Bramford to Twinstead Reinforcement

**Document 8.9.5: Temporary and Permanent Access Technical Note –
Suffolk County Council**

**Final Issue A
January 2024**

Planning Inspectorate Reference: EN020002

Drawing title: **AB-AP5
Proposed Visibility Splay
Concept Design
Sheet 1 of 1**

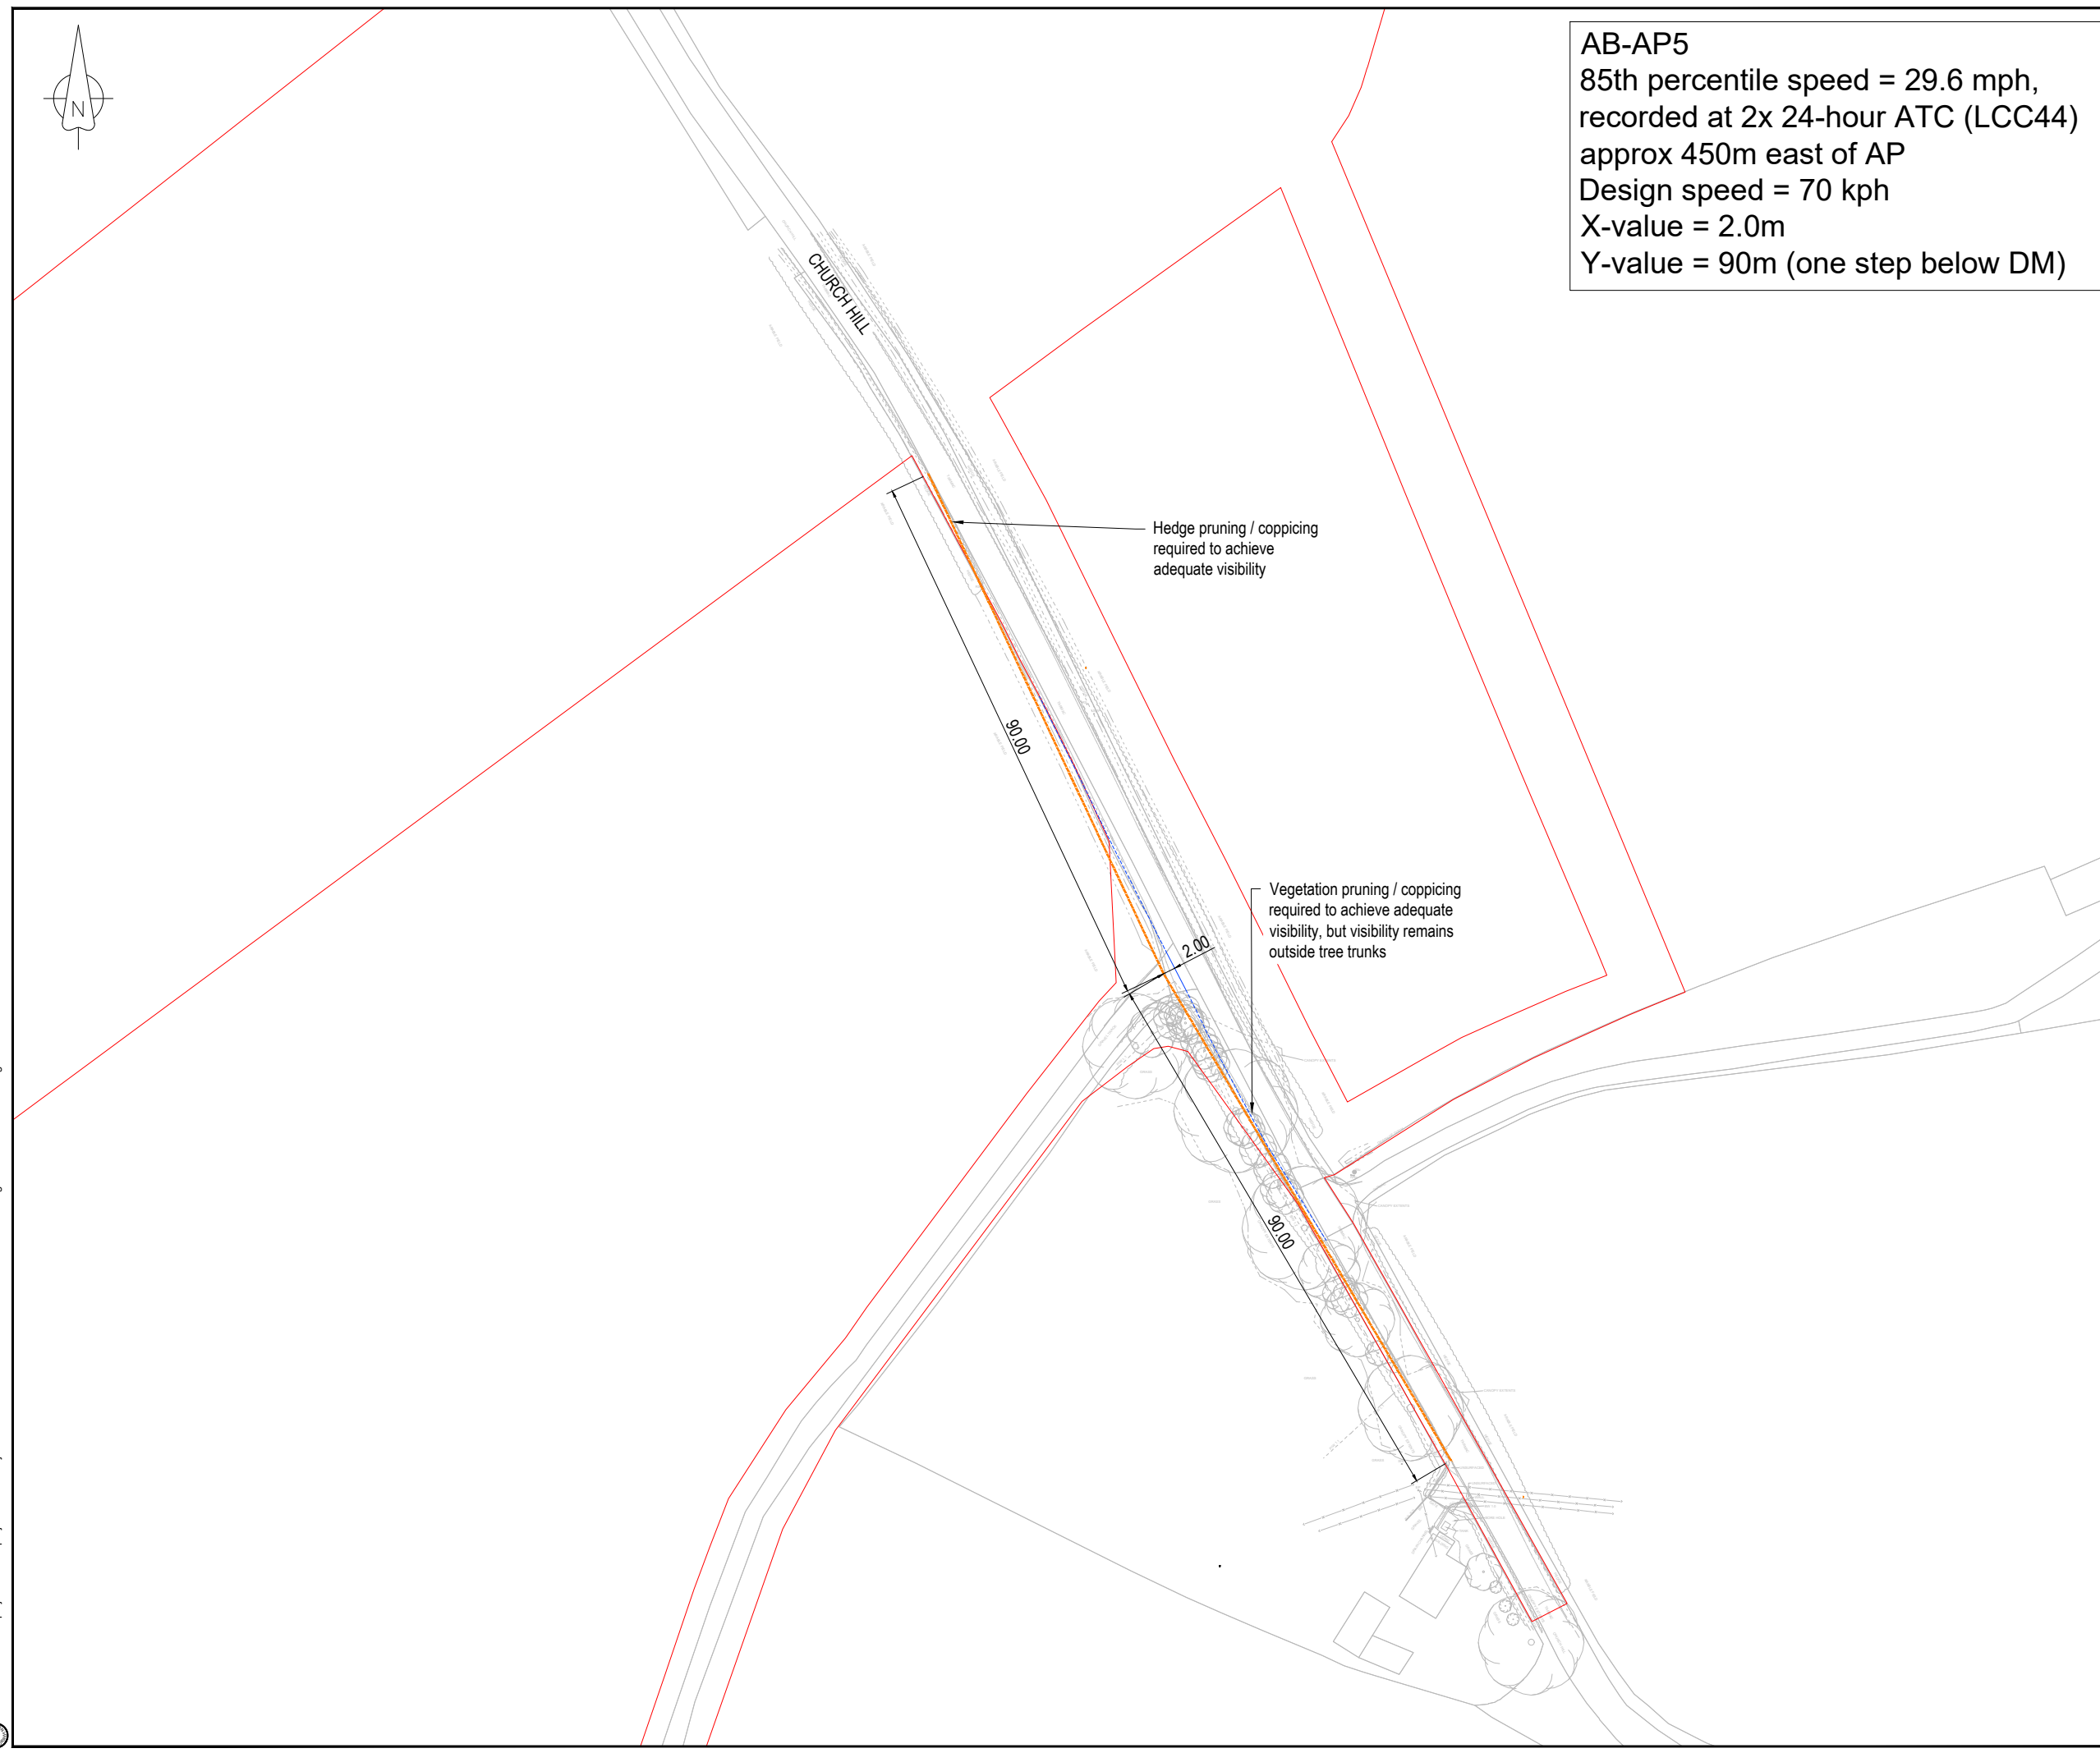
- 2.1.3 AB-AP5 is located north of a bend in the road, which is considered likely to reduce vehicle speeds at the access point and means that visibility to the south of the access point is limited primarily by the curvature in the road rather than by vegetation. The Applicant has drawn a visibility splay based on nearby traffic survey data, indicating that 70kph is the expected upper limit of the 85th percentile design speed, yielding a y-value, or distance along the major route of 90m (one step below the desirable minimum stopping sight distance). The Applicant has also considered the National Highways Design Manual for Roads and Bridges (DMRB) CD 123 – Geometric design of at-grade priority and signal-controlled junctions cl. 3.8, and proposes a x-distance of 2m which is appropriate for direct accesses. The x-distance is the distance away from the carriageway edge where the viewpoint of a driver of an emerging vehicle is positioned.

- 2.1.4 The Applicant has carried out a topographic survey in this location, which has determined that Church Hill widens in the vicinity of the existing private access. However, by maintaining the existing carriageway width of approximately 4.8m south and north of the junction by way of an edge-marking solution, the driver's eye position can be brought further down the access track towards Church Hill itself. This will essentially formalise the existing situation, where the carriageway extends towards the access track but the delineation point between Church Hill and the access track is the extension line of the edge of carriageway either side of the access, as shown in the screenshot below.

- 2.1.5 The visibility splay shown in Appendix A requires the coppicing and pruning of vegetation within the functional highway to achieve the dimensions set out above, but the topographic survey has shown that the visibility splay does not interact with any surveyed tree trunks. Speed surveys are being carried out in January 2024 to confirm that the 70kph 85th percentile assumption is appropriate. Assuming that the speed surveys confirm assumptions to date, the visibility splays shown in Appendix A are considered appropriate. If the speed surveys show greater speeds than expected, the visibility splay shown would be revisited to determine whether a greater splay would be required or an alternative mechanism introduced to deliver an appropriate access.

- 2.1.6 The Applicant has also commissioned a detailed arboricultural survey of the trees to confirm the impact on the trees of the proposed pruning and improvements to the access. The Applicant considers it likely that the arboricultural survey will corroborate assumptions made to date, but given the discussion with the landowner on the trees, the survey is being completed to provide certainty. Information on the speed survey, arboricultural survey and any revisions to the sketch in Appendix A (if required) will be submitted into Examination at Deadline 8.

Drawing title: **D-DAP1: Rands Road, Layham
 Proposed Visibility Splay
 Concept Design
 Sheet 1 of 1**

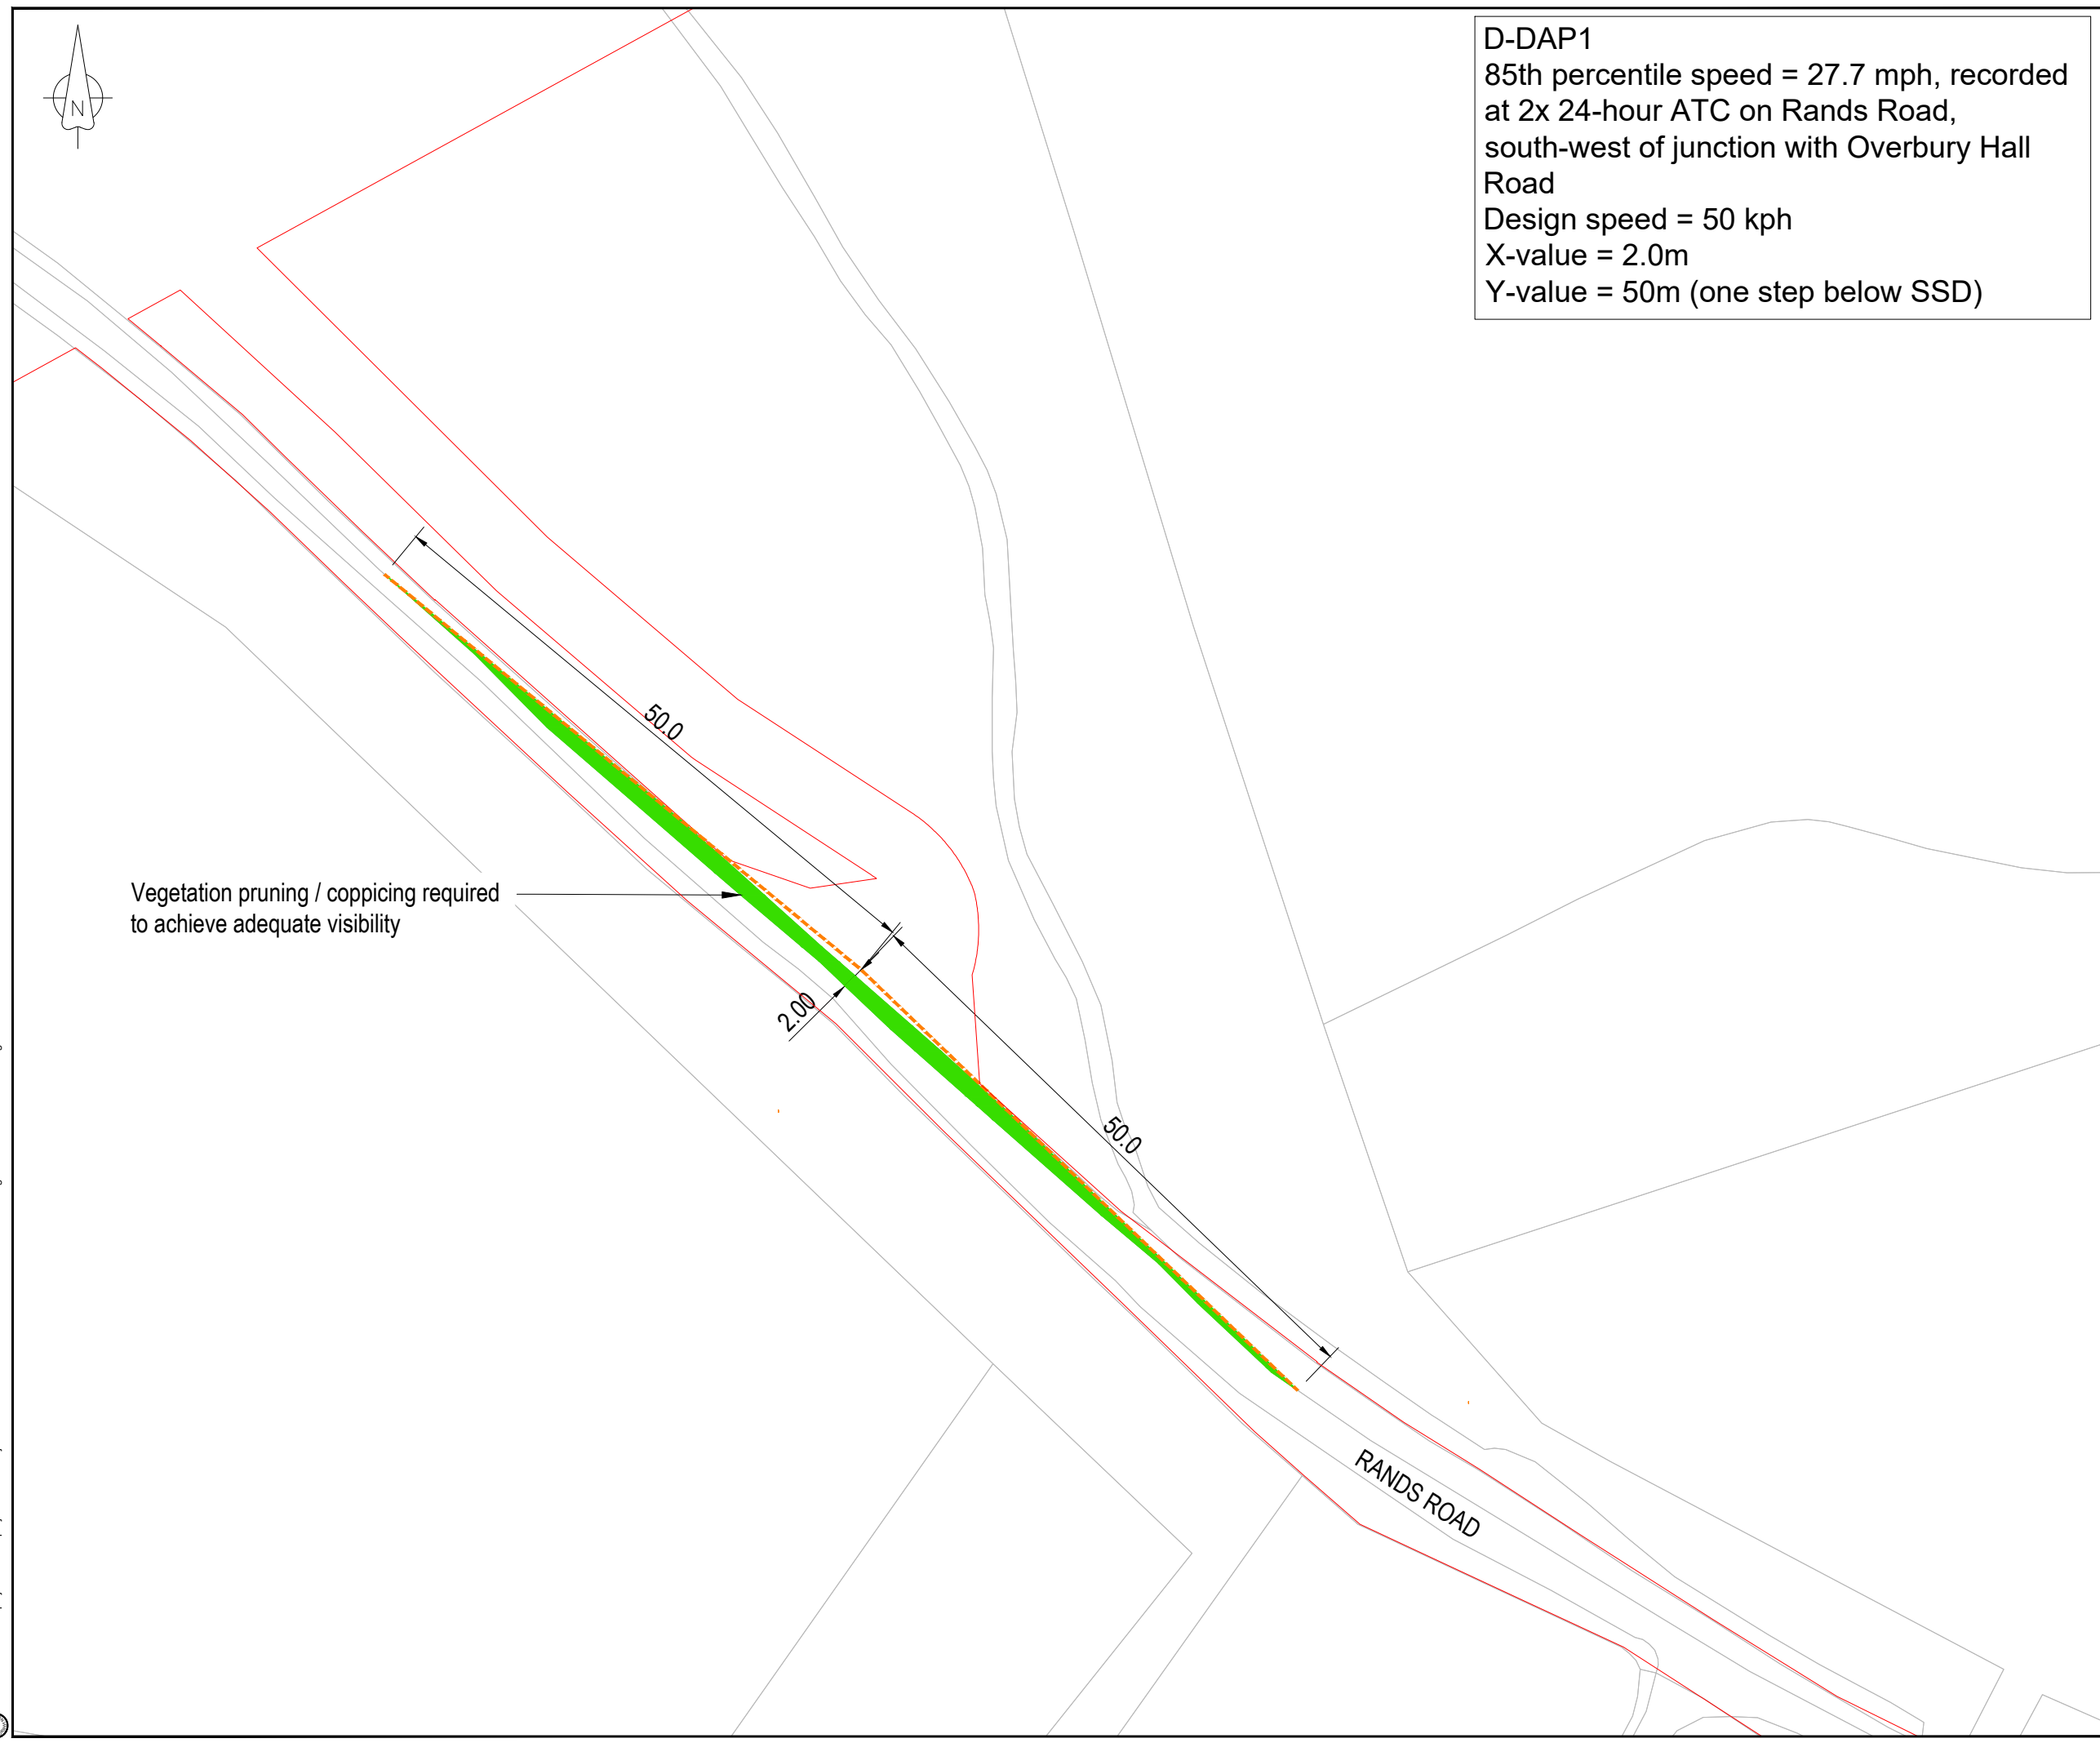
- 2.7.5 In initial discussion with SCC, it was noted that:
- Rands Road is in effect a single-track road, so any activity is likely to require a temporary closure. Closures might be necessary to prevent a works vehicle or other large vehicle reversing long distances should they meet on the route;

- A mature tree seems likely to require removal to achieve the access bellmouth; and
 - A private means of access to the east provides a location where a works vehicle may turn if necessary, with a banksman.

- 2.7.6 The combination of these aspects means that this access, which is only required for removal of the 132kV line, could have excessive impact on vegetation. Therefore, given the single track width and small scale nature of the work (primarily unloading plant/materials and loading removed apparatus), it may be appropriate to use a short-duration closure to create a more modest area of vegetation removal on a road-field boundary as an access to the adjacent farmland. This would be explored during the detailed design stage, but discussions confirmed that solutions were available. These noted that traffic management measures are likely to provide a more proportionate approach for this lightly-used access, to avoid excessive vegetation removal to provide the full visibility splay.
